# Management Summary and Reporting Memo

## on Verification Observations on Landis+Gyr Testing Report

<b>Author:</b> Reliability Core Team Holland Innovative Sept-Oct 2017	<b>Client / contact:</b> Bert van Creij Liander Sept-Oct 2017
--	--

Ref [1] Report name and number: Not explicitly available. Filename: Infield test report 21 9 17.docx. (First) Report header: *DSMR4 AND SMR5 EURO METERS - DEFERRED THREAD TESTS - OVERALL SUMMARY REPORT*. Date according to report: 19-Sept-2017, Date according to file: 21-Sept-2017. Authors/contributors: Landis+Gyr – David Ballantine, Richard Brighton, Tony Waters. Confidential.

## 4.3 Verification observations on "HALT – TCIVB"

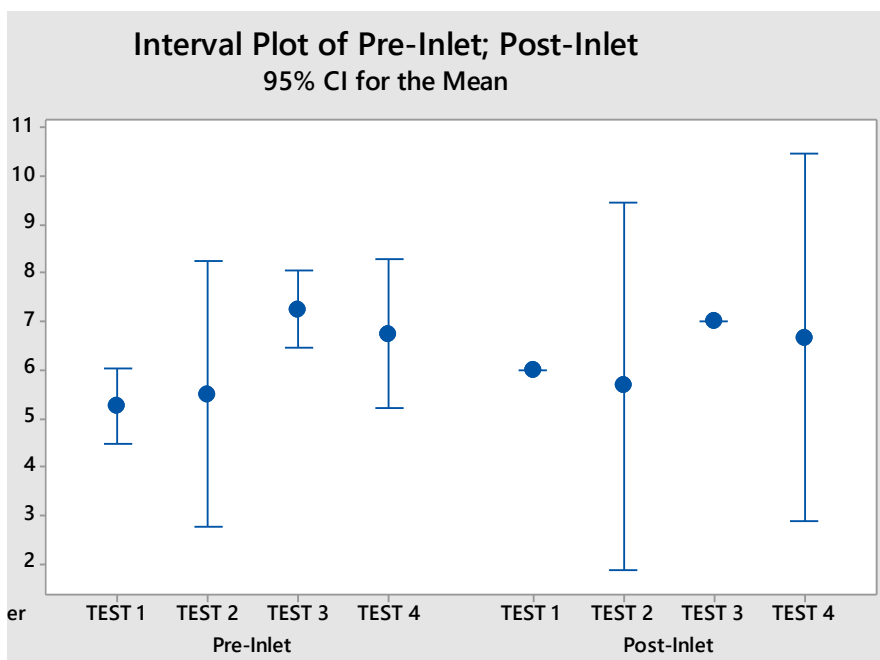
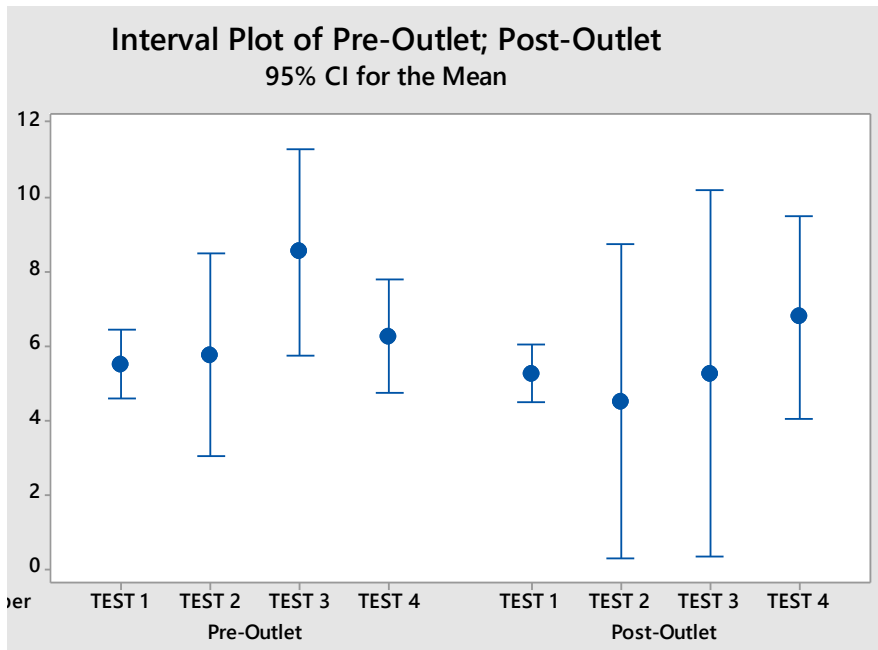
The statement "The test showed there was no difference between standard and deferred meters." has not been (*statistically*) proven. On beforehand, no confidence or test set-up basis has been provided (why 2x4 for both bosses). It can be said that "It has not been proven that there is a (positive or negative) difference between deferred and standard threads with respect to leaks at XYZ location" – this should however NOT be translated as "So the standard and deferred bosses are proven the same".

The statement "The test did show that the nut to boss joint was the weakest in respect to leaking" is not substantiated, for example by finding other leak locations (internal or external) failing sooner in the same test.

The statement on "functionally failing before leakage": see later in memo at relevant DoE.

Pass/Fail criteria of the leak test do not detail the leak location on the meter/manifold combination and how is proven (tested) that no other leaks (and/or other locations than the relevant boss/nut location) have occurred.

No relationship between degrees loosening / tightening and its progression throughout the test and leakage is observed.

The statement that the tightening torque increased as the test progresses cannot be statistically proven, see graphs (next page) with the measured torques (shown in Landis+Gyr table) – no trends upwards or downwards can be observed. The measurement system has not been analyzed by Landis+Gyr with respect to systematic and random error, and the measured torques are depicted as integer (no decimals). In addition, Two-sample T-tests show no significant difference 'over time' between the measured torques throughout the tests progressing. Also, regression lines did not show significant correlation between test progression and measured torques ( $R\text{-sq} < 20\%$ ).
